REVIEW OF PROPOSED STRUCTURE PLAN TO BETTER PROTECT LANDSCAPE AND VISUAL VALUES

prepared by Anne Steven
Registered Landscape Architect

November 2021

Plan Change 14 Modified Structure Plan
Aerial Overlay
19/10/2021

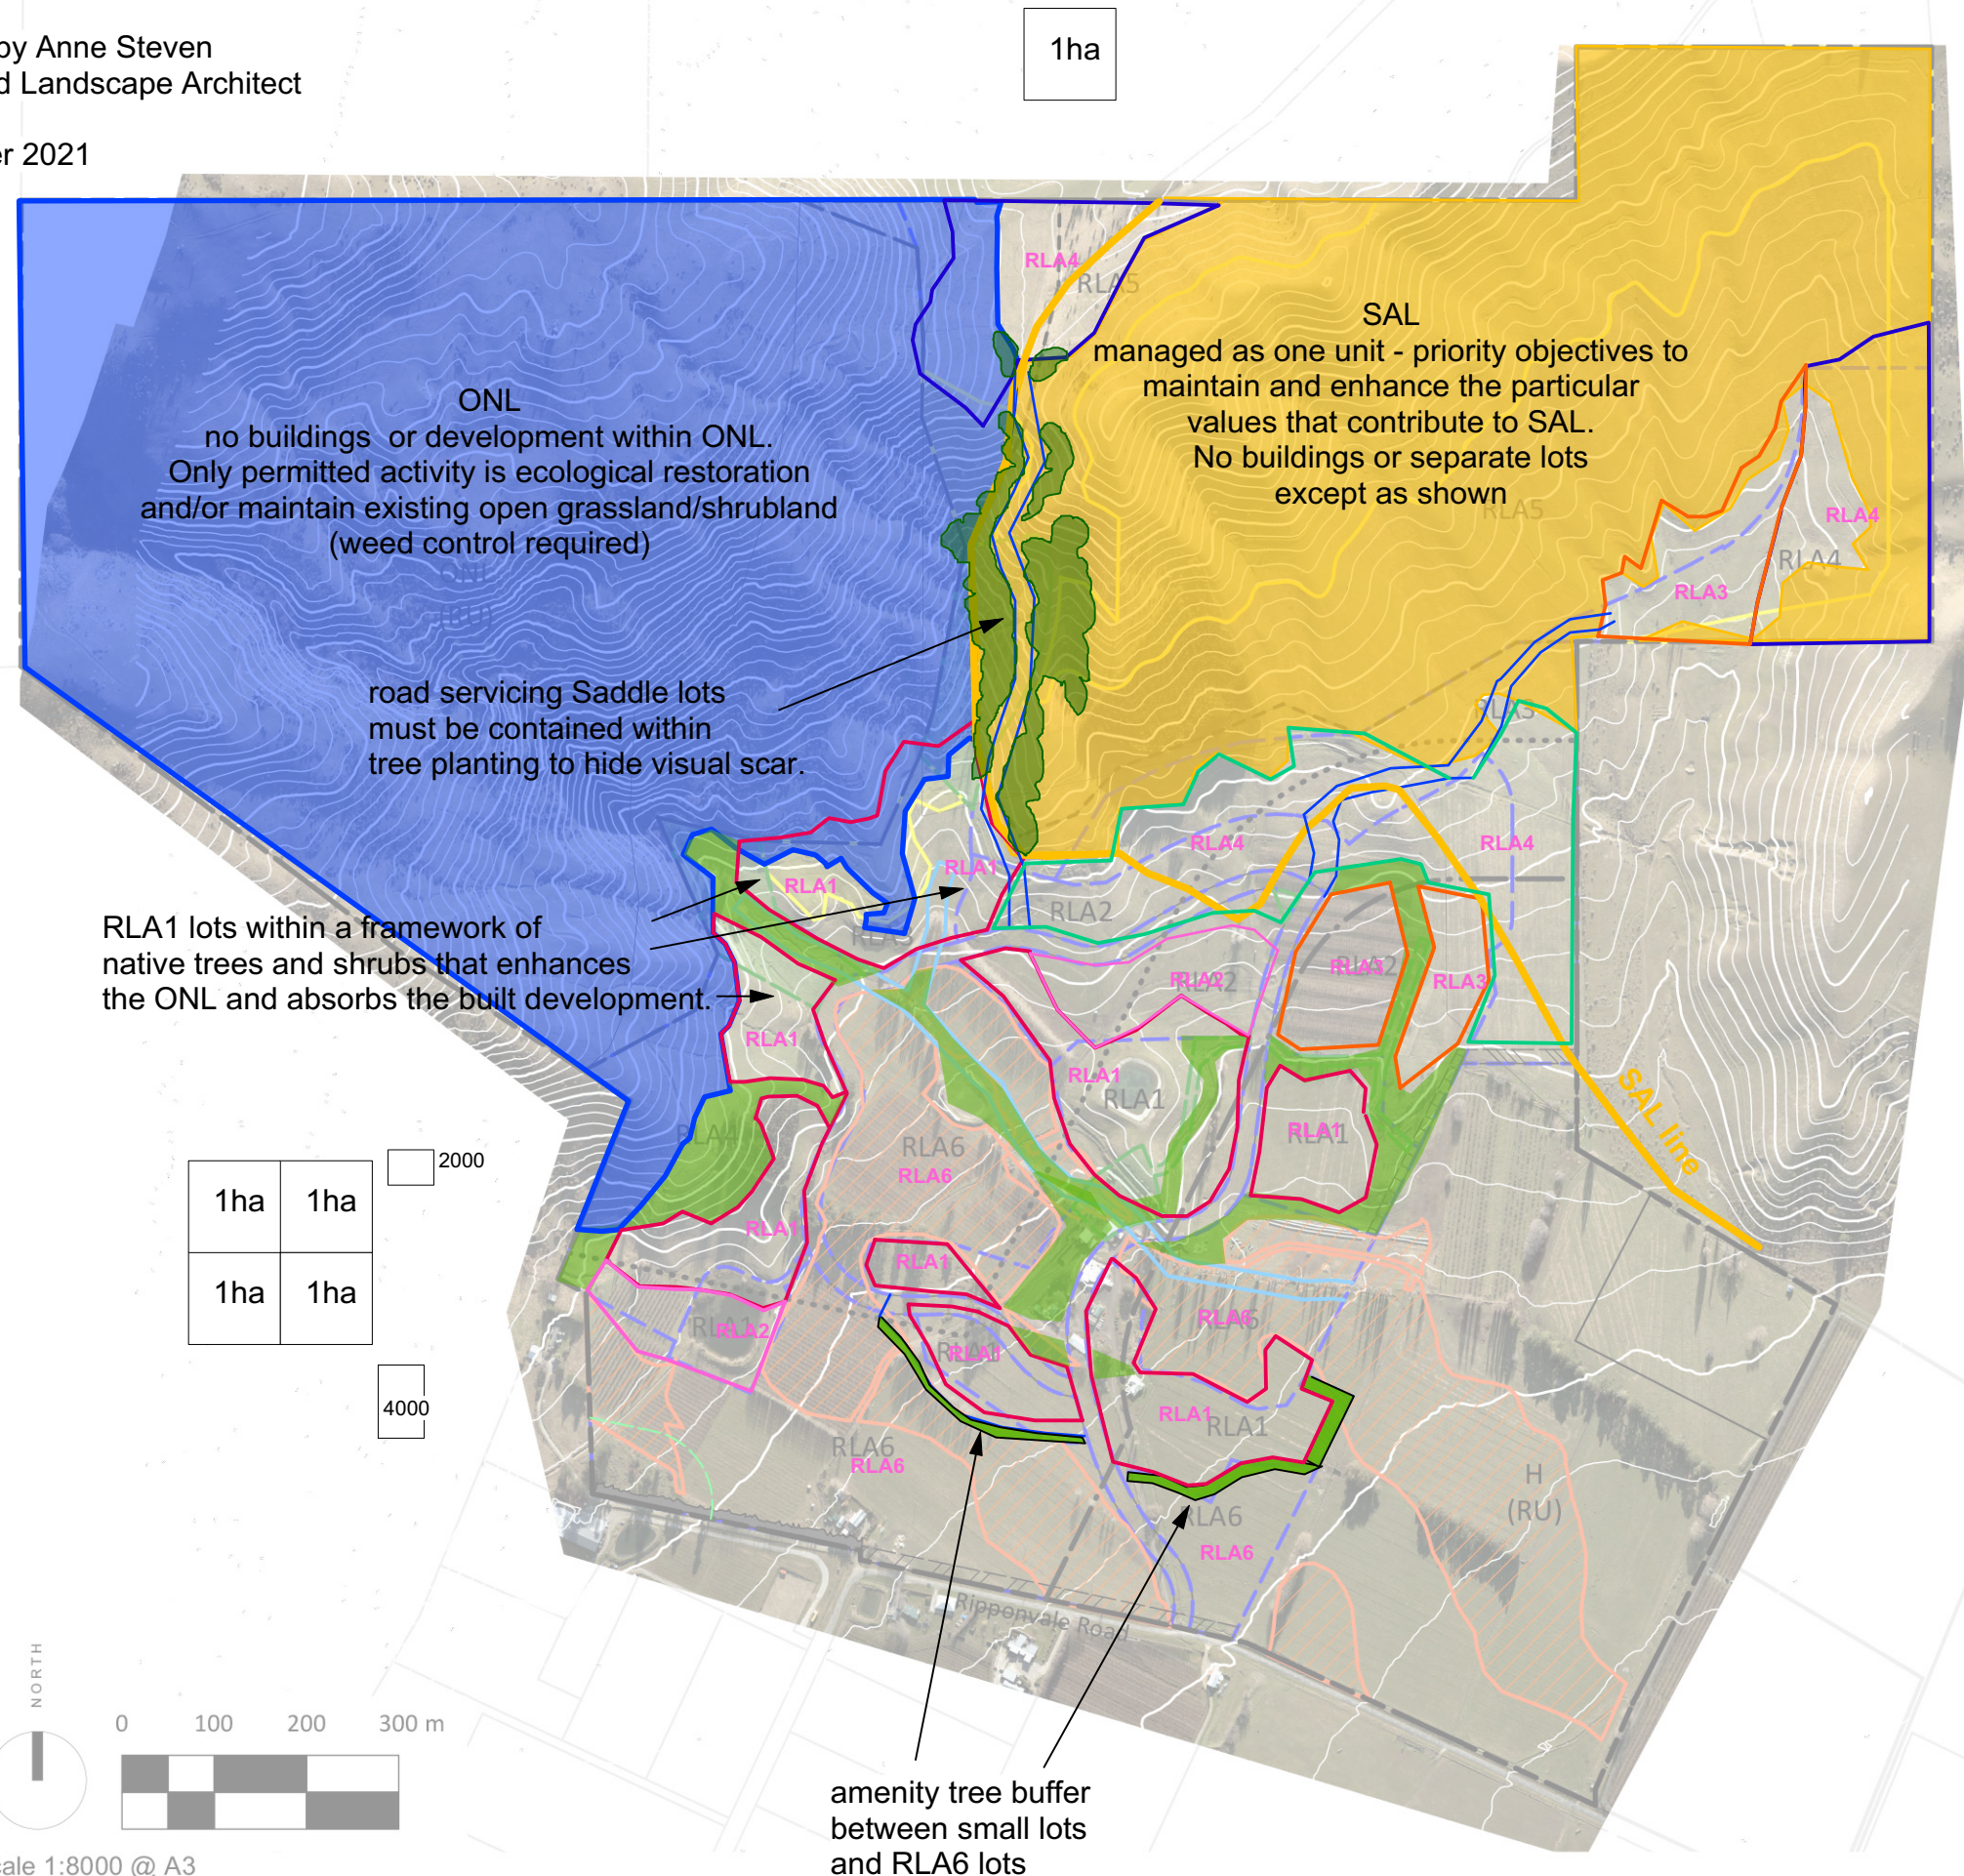
1. no development on the bulk of the SAL to best ensure it remains a cohesively managed open pastoral block of land. It is able to continue to express its particular landform values, which rely on the simple open character and a relative absence of fragmentation.

2. As agreed, there is some scope for development in the bottom of the valley to the east (ideally this would be within a unifying tree planting framework related to the landforms but this could come later as a detail layout plan??)

3. Larger scale lots on the lower southern flanks of the SAL (RL4) to achieve a larger proportion of open space and a more rural character; as this is a visually exposed and sensitive part

4. an increase in potential areas for RLA1 development in pockets around the base of the slope, where because of the angle of view the "front" development tends to mask development behind. Against the ONL and in the ONL, I envisage this being within a native planting framework to enhance the ONL, and unify and absorb built form.

5. Tree vegetation in the separating valley to mask the road to the saddle (and enhance ONL/SAL)
6. open space network slightly rejigged
7. amenity tree buffer as agreed on far side of RLA6 lots bordering Ripponvale road.

amenity tree buffer
between small lots
and RLA6 lots
